Motorola Solutions Technical Notification (MTN)

TITLE: Alignment screen from CSS A2019.1 is not compatible with MsBR's (base stations) from A7.17 and A7.17.2.

TECHNOLOGY: ASTRO 25

DOCUMENT NUMBER: MTN-0011-22-NA
APC: 877
ISSUE DATE: 01-2022
EXPIRATION DATE: 31-01-2023
Bulletin Type: Informational Only

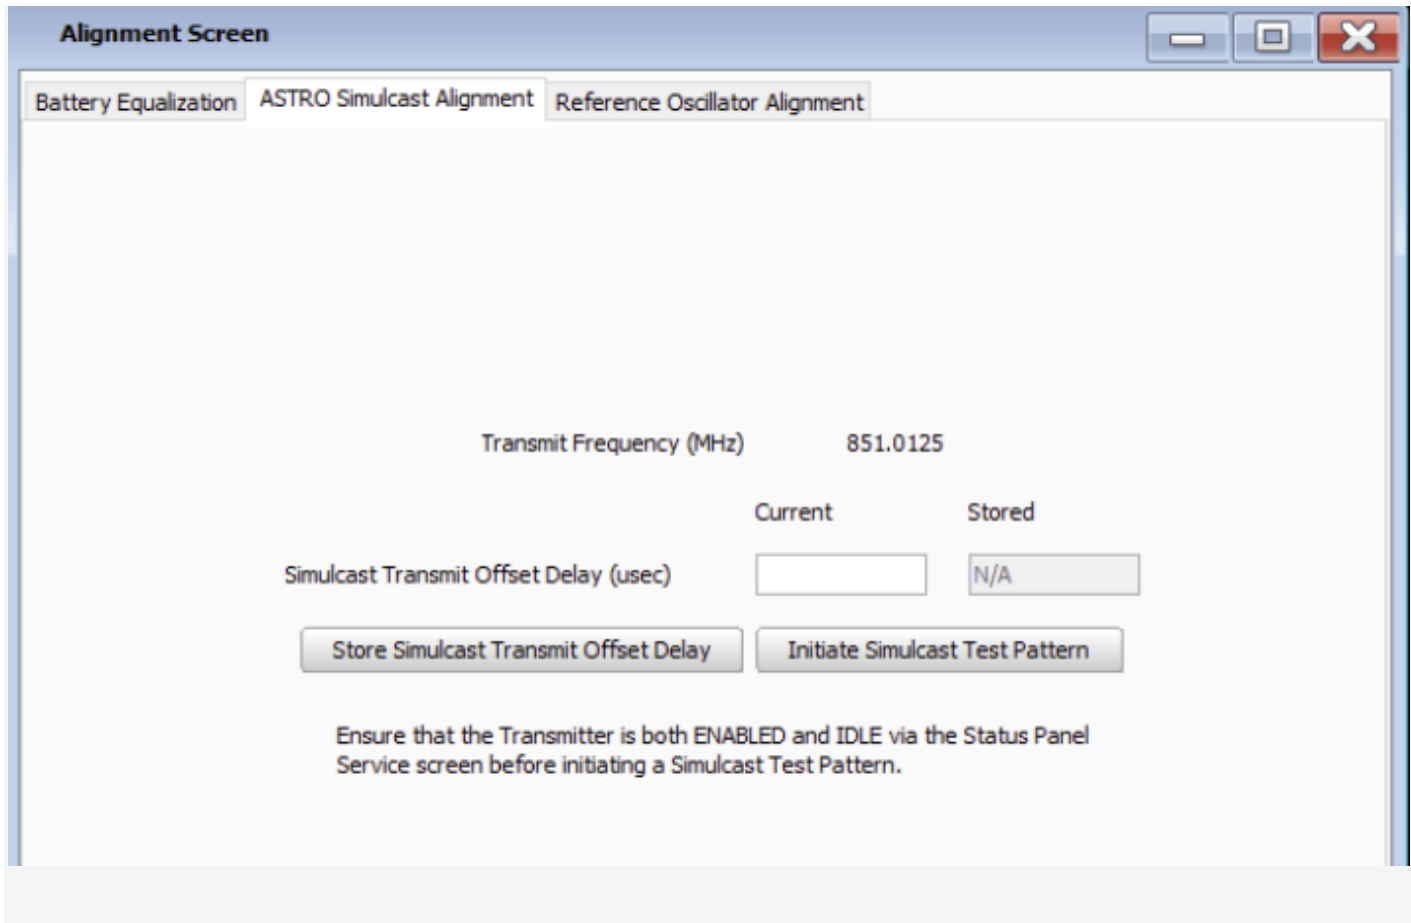
SYMPTOMS:

1. Open CSS and read configuration from MsBR device
2. Open Alignment screen, change Offset Delay value and write it to device (Simulcast Transmit Offset Delay button)

3. Offset Delay value is not properly written to device: When you re-open the screen stored Offset Delay values are empty (previous value does not remain).

WORKAROUNDS AND CORRECTIVE ACTIONS:The problem has been corrected in CSS (**KC491V004000190103**).

When problem occurs, upgrade CSS to appropriate versions: either the latest **CSS A2019.1 (KC491V004000190103+)** or CSS from "**PrevRelease\7.17.x to 7.15**" folder from the latest **CSS A2020.1 (KC491V004000200106+)**.
